## Objection to planning application 2019/5835/P - 4B Hampstead Hill Gardens

Current West elevation - drawing

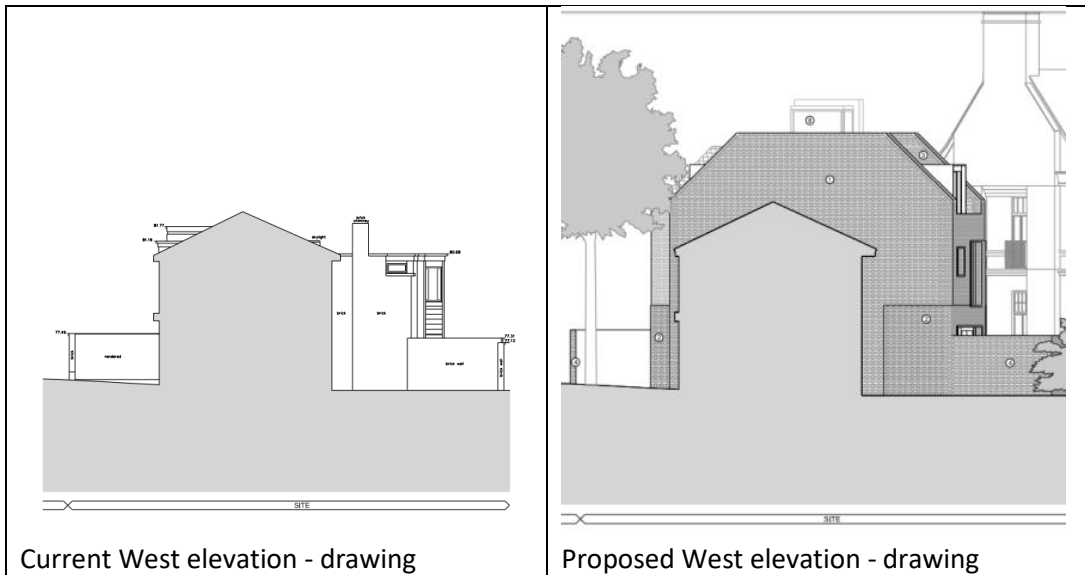
**Additional height leading to loss of light, overshadowing, and privacy issues:** The proposed structure for 4B will add over a storey of height to the main sections of the current house. This will block essential light to almost all of 4A's main windows which, it should be noted, are mainly on the south and east elevations and already suffer from limited light due in part to 4B's existing rear mass. In particular, the kitchen/dining area, where much time is spent, will be completely overshadowed, and light taken from the east-elevation windows, which directly face the west elevation of 4B. The garden, too, will be oppressively overshadowed by the overbearing additional storey. The small patch of sky above the current rear mass of 4B, which we now enjoy seeing from the windows and garden, and which provides light, will disappear, blocked out by the new structure. Similar negative impact, along with privacy intrusion in several cases, will result for the surrounding houses and gardens (as noted in other objection letters). The scale of the proposed change is very clear from images in the planning application itself, as well as a set of drawings from the "Heritage Statement" commissioned by residents, as reproduced here:
